RE: REVISED DRAINAGE PLAN FOR 50 ROOM MOTEL (K-21/D16E)
REVISION DATE OF MAY 12, 1992

RE: REVISED DRAINAGE PLAN FOR 50 ROOM MOTEL
(K-21/D16E) REVISION DATED AUGUST 26, 1991

GRADING AND DRAINAGE PLAN 50 ROOM MOTEL TRACTS 1-CIA-4 & 1-CIA-5 OF HORNE DEVELOPMENT ADDITION

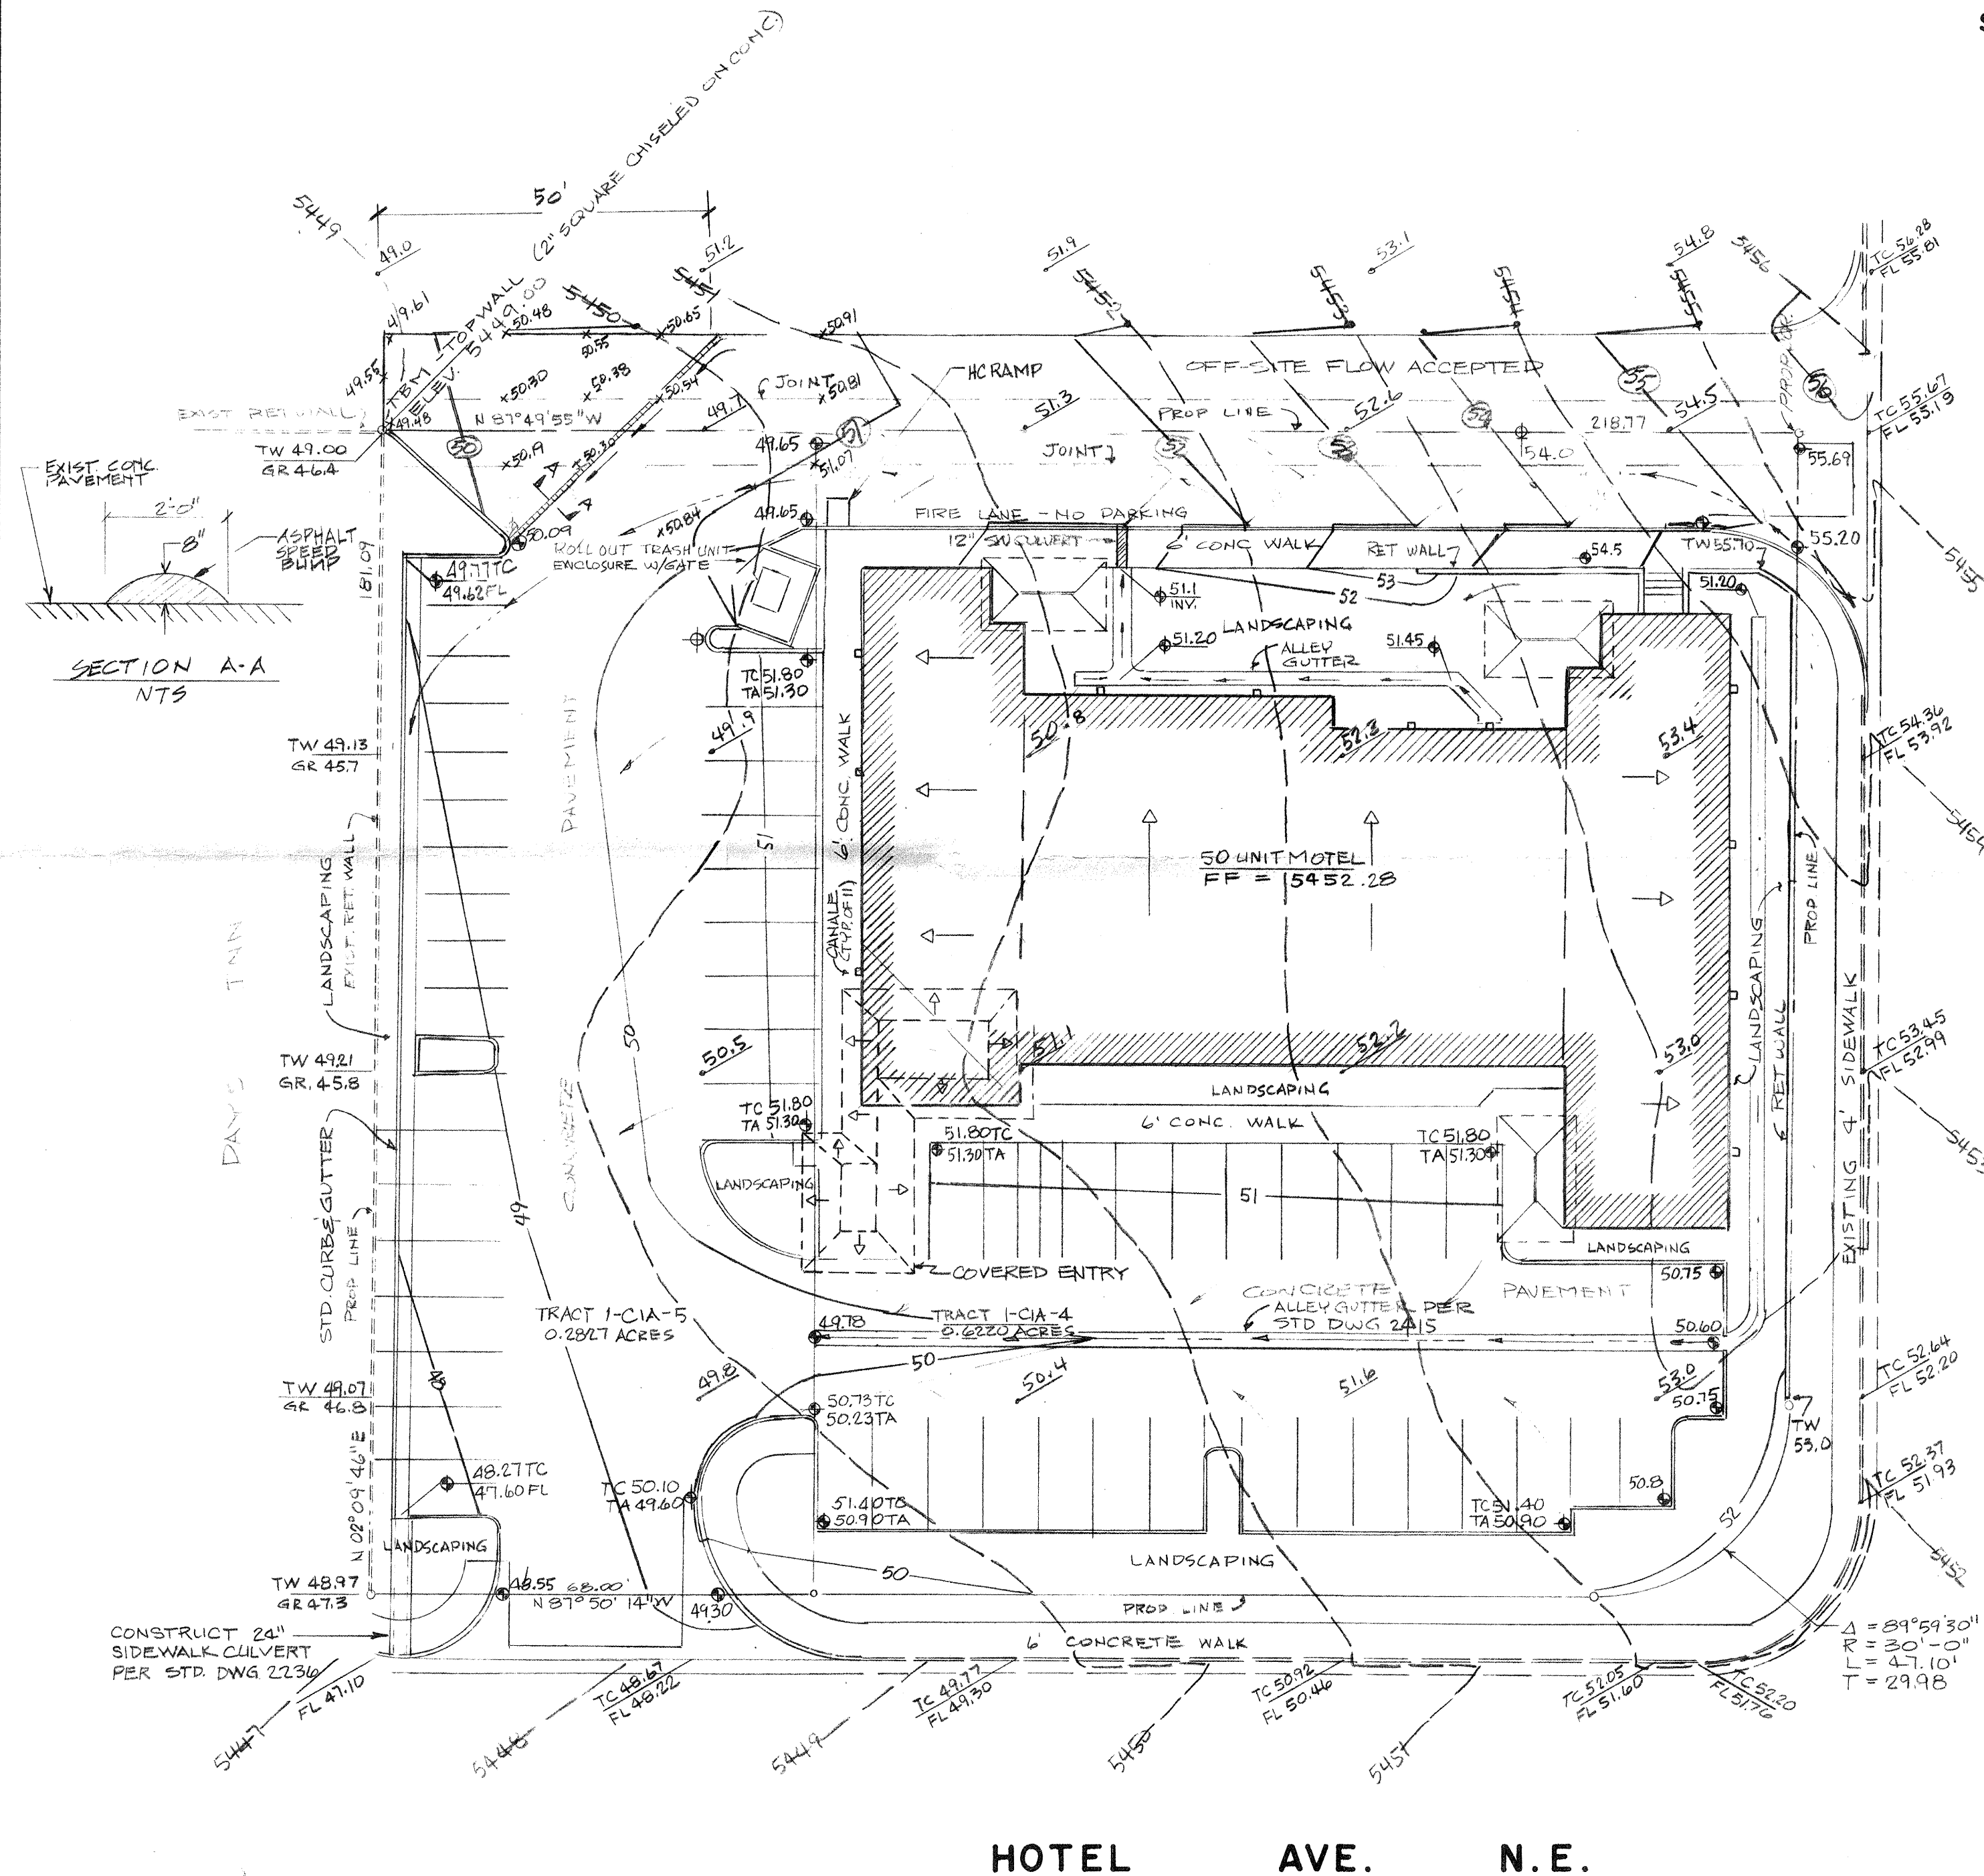
Please advise your client that once the asphalt bump to re-route the flows in constructed, they will need to call for a reinspection.

SHOWED AS-CONSTRUCTED GRADES ON
NORTH SIDE. SHOWED PROPOSED ASPHALT
SPEED BUMP TO DIVERT RUNOFF FROM
DRIVEWAY PER APPROVED PLAN, ATTACHED.
SITE DEV. PLAN SHOWS ACCESS EASEMENT
FOR PAVEMENT NORTH OF N. PROP. LINE
DATE SUBMITTED: MAY 12, 1992

Based on the information provided on your resubmittal of May 12, 1992, the referenced site is approved for revisions as shown.
